PRELIMINARY DRAINAGE REPORT FOR BRADLEY POINT FILING NO. 1

**PCD-ENGINEERING REVIEW COMMENTS
IN BLUE BOXES WITH BLUE TEXT**

December 2020

MS-21-002

Figure 12-20. Sloping broad-crest weir

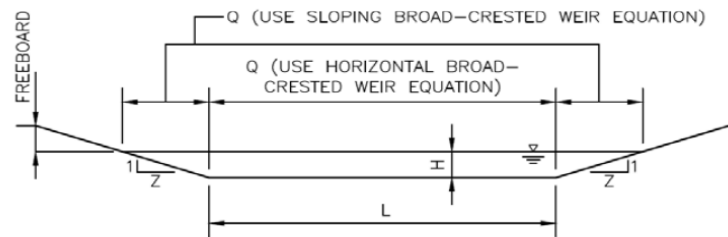
Provide roadside ditch and downstream conveyance calculations.

BRADLEY POINT FILING NO. 1 - EXISTING DRAINAGE MAP

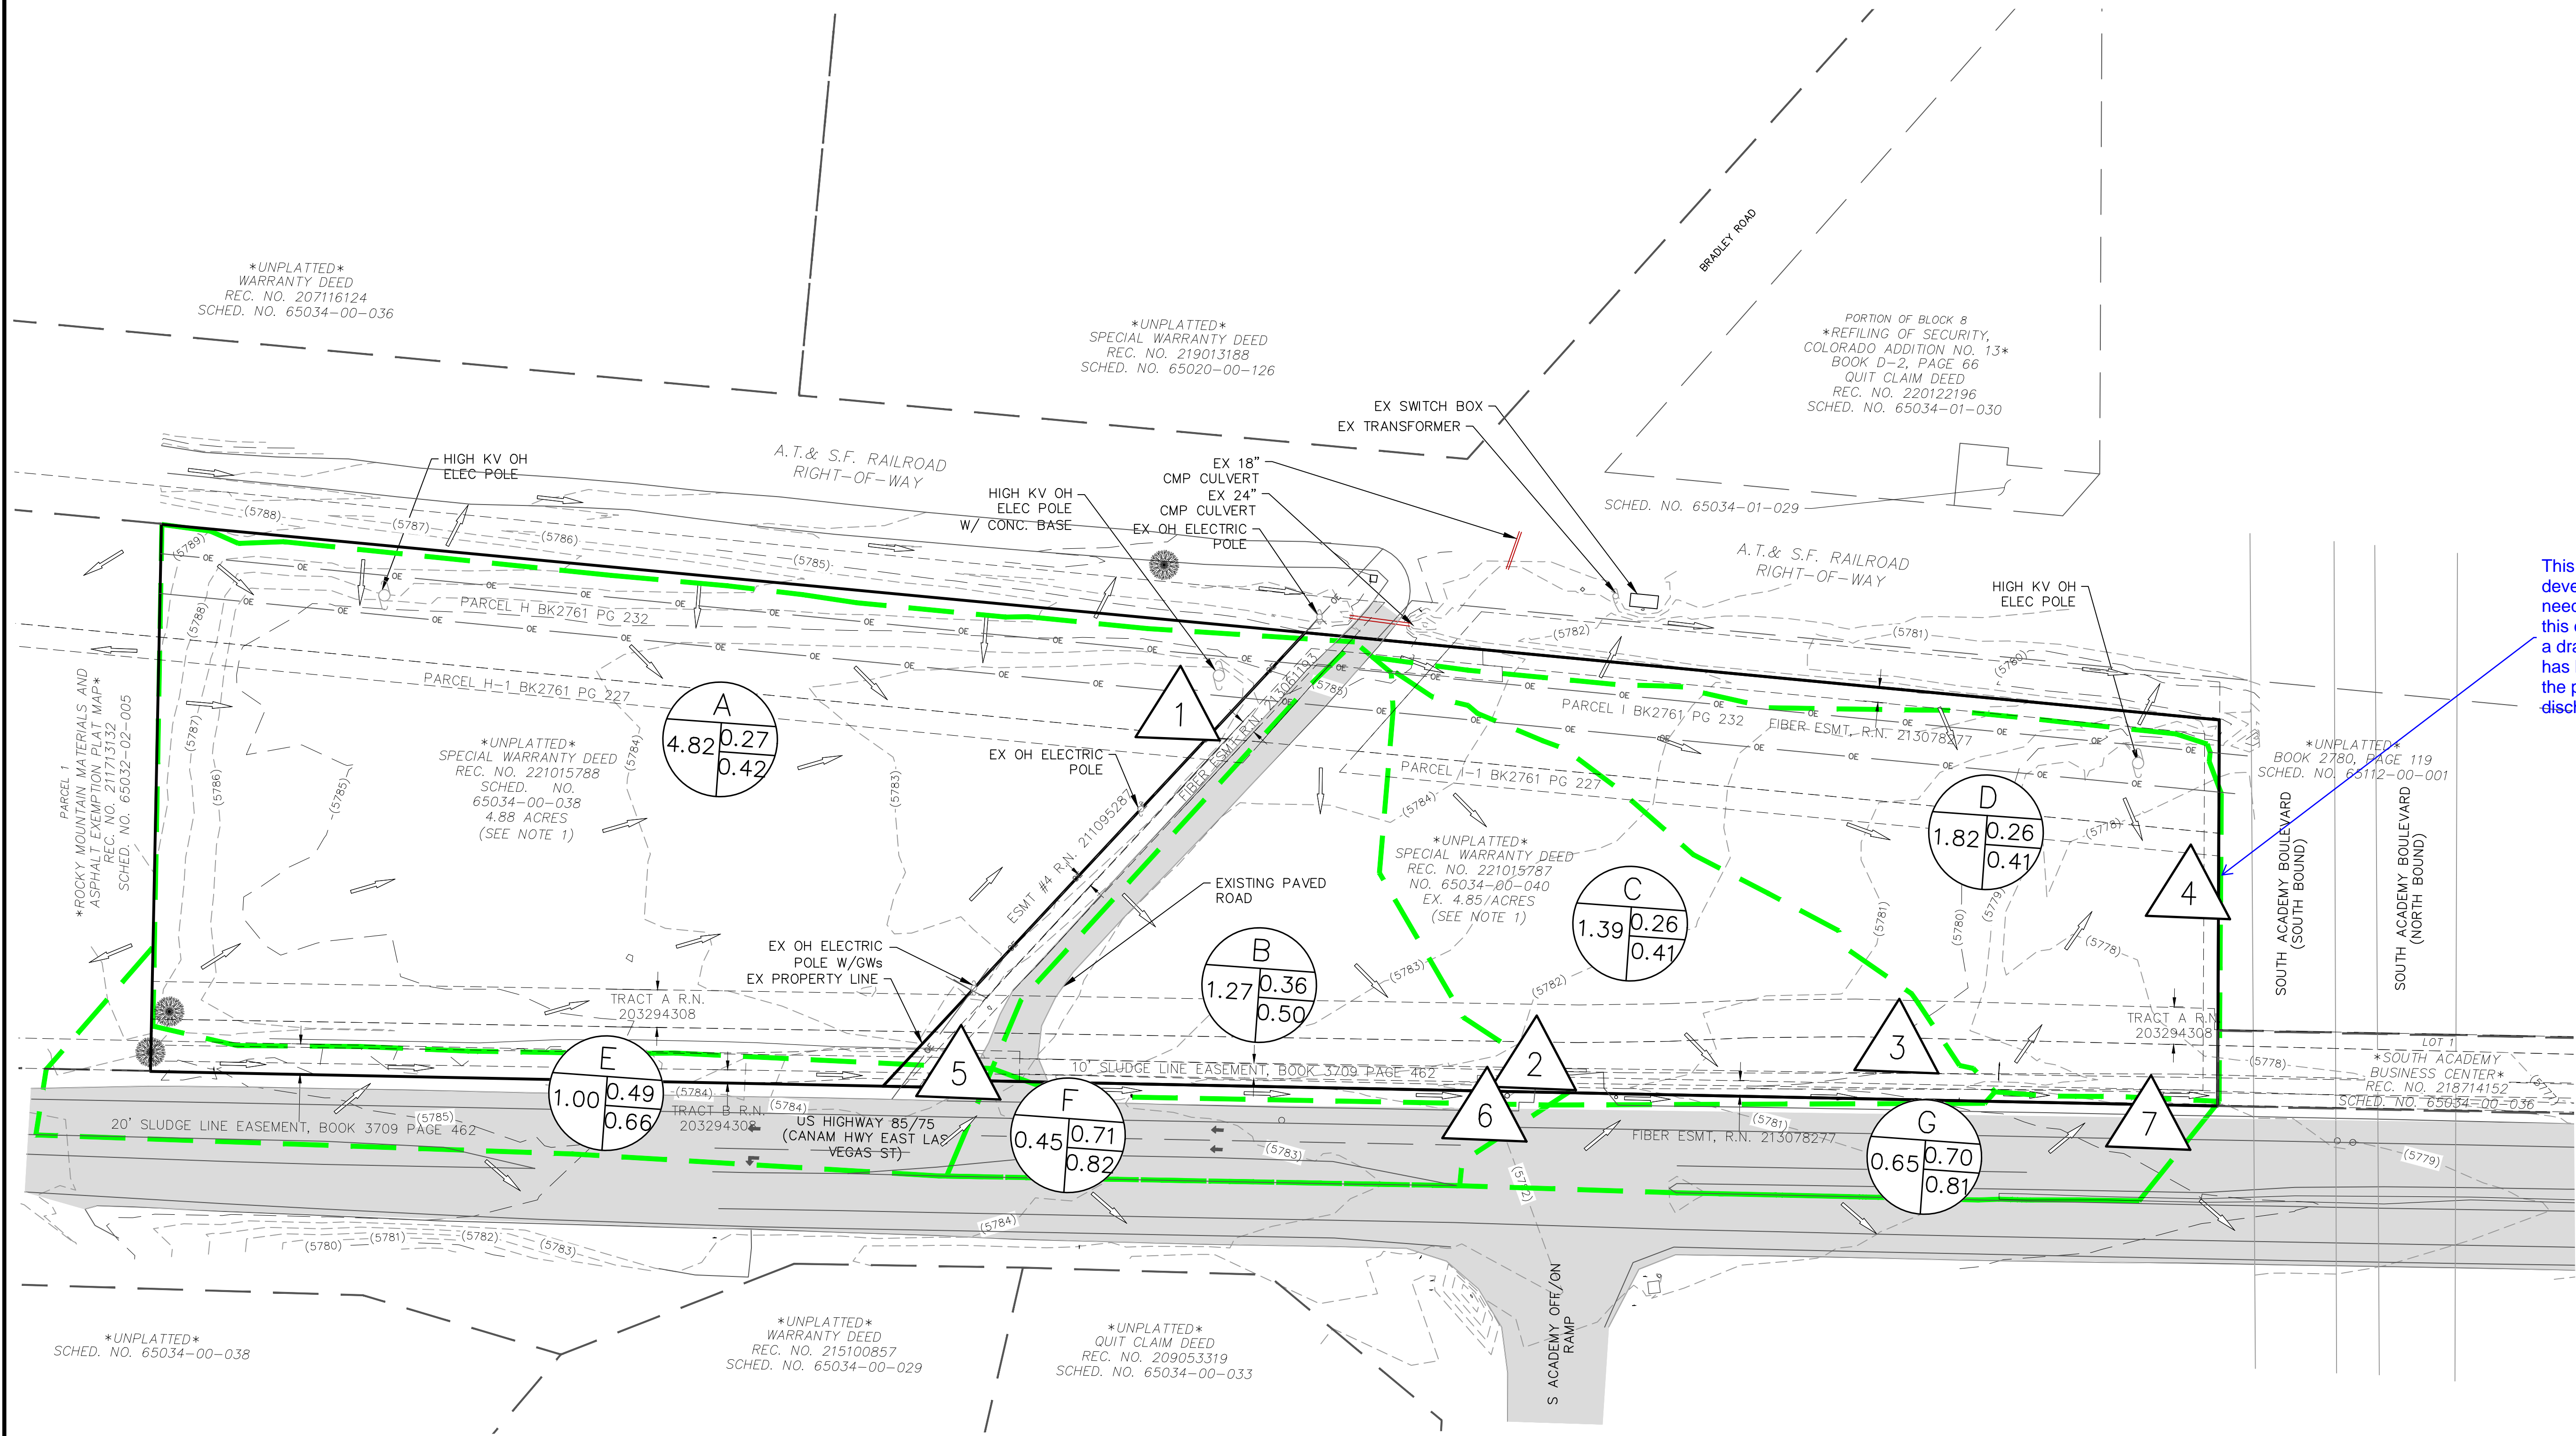
Does the ditch have capacity or do flows enter the site?
